CERTIFICATE OF APPROPRIATENESS

Property: 1448 Columbia Street, Lot 24, Block 161, Houston Heights Subdivision. The property includes a historic 2,340 squarer foot, one-story wood frame single-family residence and a two-story detached garage situated on a 6,600 square foot (50' x 132') corner lot.

Proposal: Alteration – Replace an existing wood pergola with a new gable roof over an existing rear porch on a contributing residence located on a corner lot. Replace the existing rear porch square wood columns with new square smooth finish cementitious columns. Install screen panels in between the proposed square columns.

EAST (REAR) ELEVATION

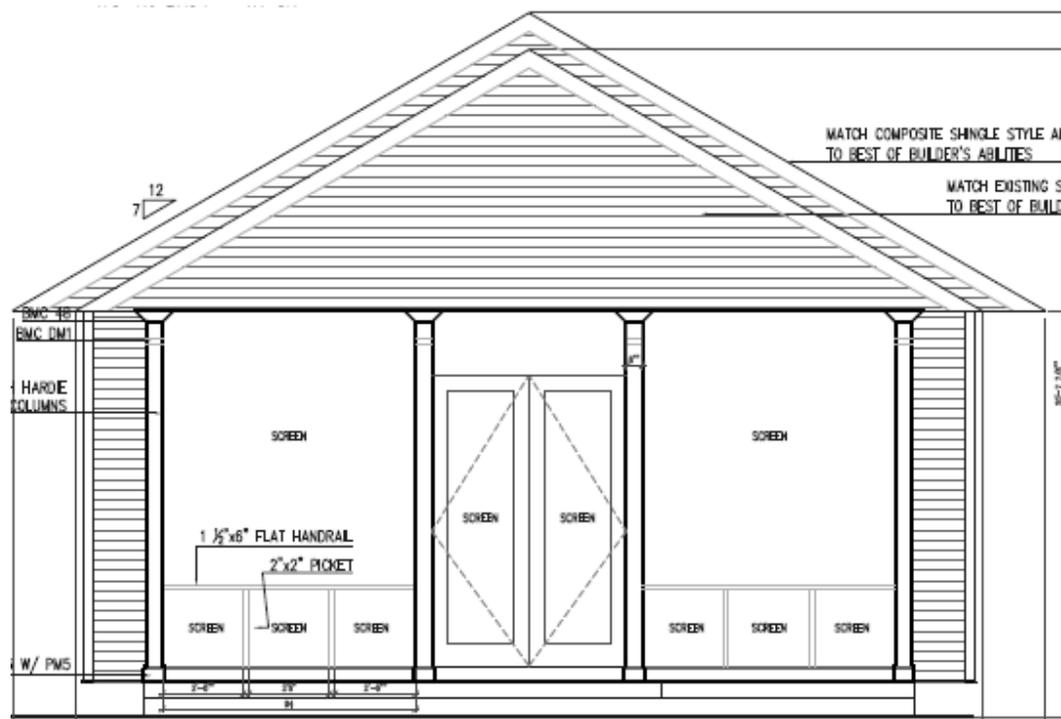
1448 Columbia St - The report for this proposal, as it reads now, shows elevations that the existing rear window will remain. However, the description states the window will be removed and replaced with siding to match. I would support this project only on the condition that the existing original window remain.

The applicant proposes to remove an existing window from the east side of the structure – an existing window on the northeast corner of the rear wall of the existing structure between the door and the north wall. This proposed activity would not preserve the historical character of the property and does not satisfy Approval Criteria #1, #4, #8, and #9

The applicant proposes to add a roof structure at a pitch that will cover up the existing attic window on the east side of the existing structure, even though the East Elevation drawing indicates "Existing window to remain". While it may remain, it will be covered by the proposed porch roof and will not be visible from the street (this is a corner lot and the rear of the existing structure is visible from 15th Street), essentially, in effect, "destroying" the attic window. Visible attic windows are a significant element of historical character within the HHEHD. Also, a typical characteristic for the pitch of porch roofs in the Houston Heights East Historic District is to be less pitch than the roof pitch of the main structure. The pitch on this proposed porch roof should be reduced and the existing attic window should remain visible. Otherwise, this proposed activity would not preserve the distinguishing qualities or character of the building, structure, object or site and its environment, and does not satisfy Approval Criteria #4, #6, and #9.
